PROJECT NAME: PRIMARY SEDIMENTATION BASIN NO.1 – SCUM SKIMMER SYSTEM

SUBJECT: ADDENDUM NO. 1

THE MATTABASSETT DISTIRCT, CROMWELL, CONNECTICUT PRIMARY SEDIMENTATION BASIN NO.1 – SCUM SKIMMER SYSTEM UPGRADE PROJECT – BID# 2022-26

WP PROJECT NO. 20950B

SEDIMENTATION BASIN No.1 - DEMOLITION PLAN SCALE: 1/16" = 1'-0"

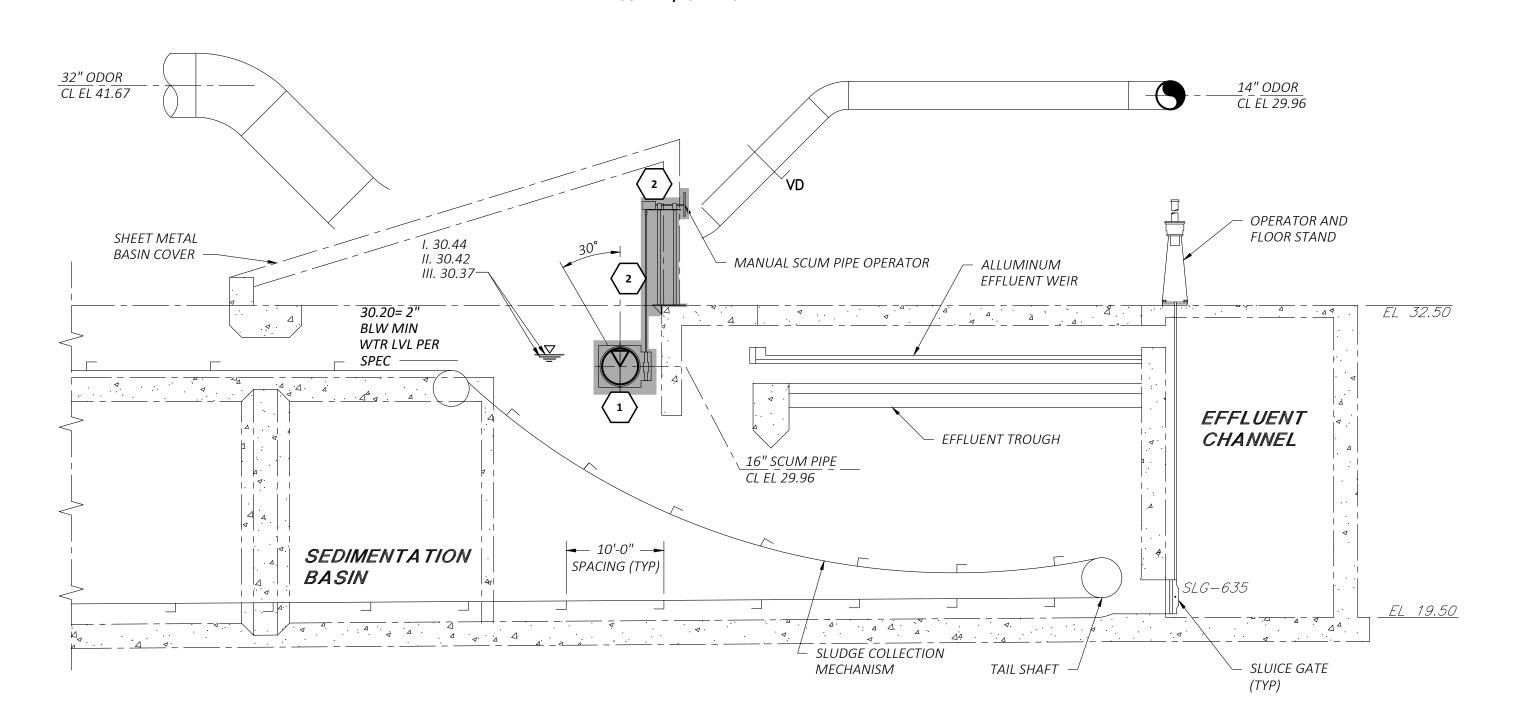
- ✓CQNTRACT GENERAL CONTRACTOR TO REMOVE AND REINSTALL ROLL-UP DOORS, FASCIA AND FLASHING AS REQUIRED TO INSTALL FALL PROTECTION HOOKS.

ALTERNATE "A"
